REGIONAL REVIEW FINDING

ARC REVIEW CODE: R7809241

Name of Proposal: Village Capital

Preliminary Report:	September 24, 2008	DEVELOPMENT OF REGIONAL IMPACT REVIEW REPORT	Project:	Village Capital #1898
Final Report Due:	October 24, 2008		Comments Due By:	October 8, 2008

GRTA DRI SITE PLAN

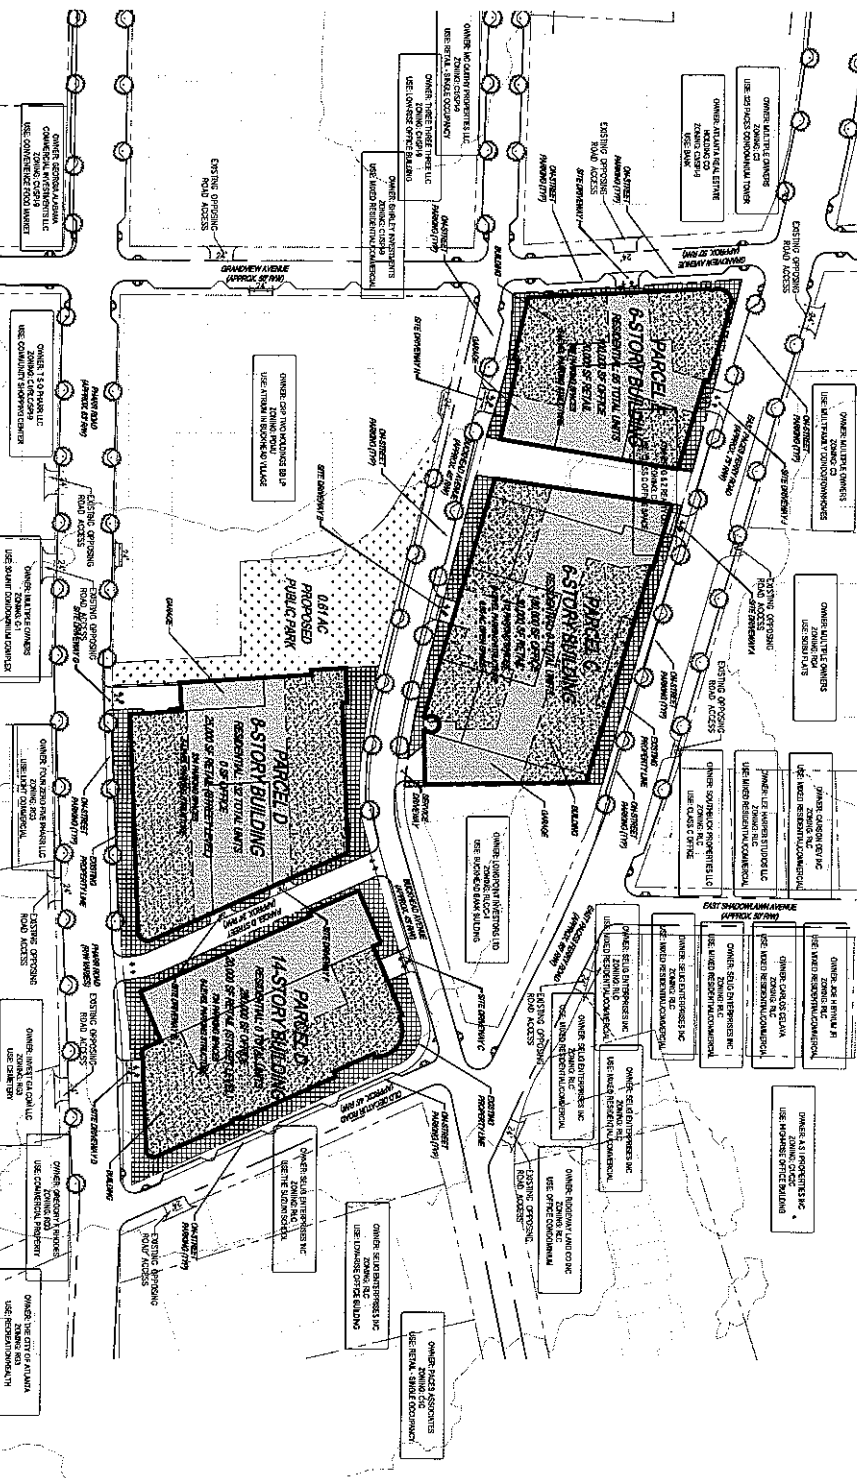
To ensure a safe and efficient pedestrian experience, driveways and curb cuts should be limited, and where necessary, should not interfere with the pedestrian zone. It is recommended that driveway C and driveway D align with existing opposing driveways or move to Parcel D Street.

- The proposed site plan adds additional sidewalk width throughout the project which will add to the pedestrian environment. However, it also proposes 11 driveways which add to visual clutter, increase pedestrian/vehicle conflicts, and degrade the pedestrian environment.

- ARC recommends reducing the total amount of driveways and relocating a portion of the remaining driveways.

- Parcel C should be limited to 2 driveways.
- Parcel D should restrict all driveways to “Parcel D Street”.
